Accessibility Survey

City of Downey Lubec Street & Paramount Boulevard

Date of Inspection
4/14/2017

Prepared By
Disability Access Consultants
(800) 743-7067

Change in Level East of Samoline Avenue @ 33.956921055875, -118.127794861794

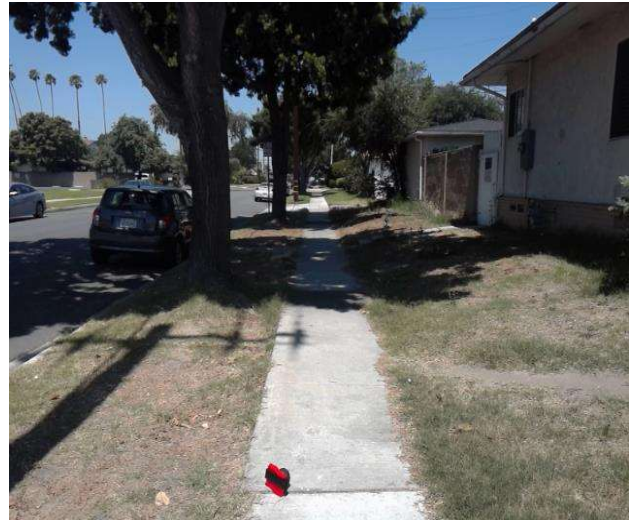
There is a change in elevation greater than recommended value.

On-Site Finding 0.50 inches

Ensure that the change in elevation is within the recommended value.

Change in Level East of Samoline Avenue @ 33.957238086310, -118.128414452076

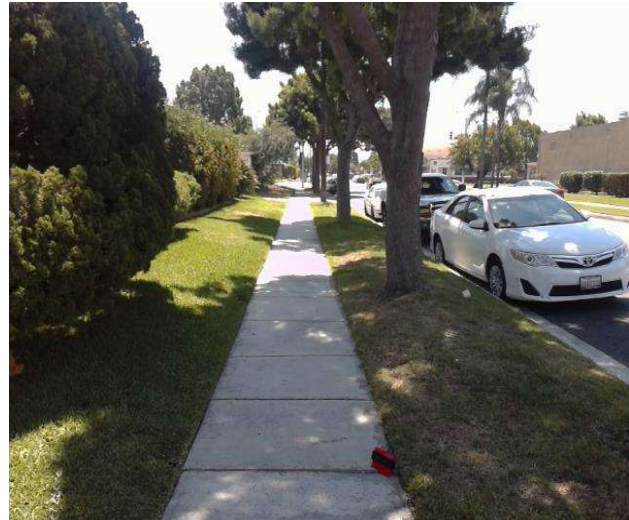
There is a change in elevation greater than recommended value.

On-Site Finding 0.37 inches

Ensure that the change in elevation is within the recommended value.
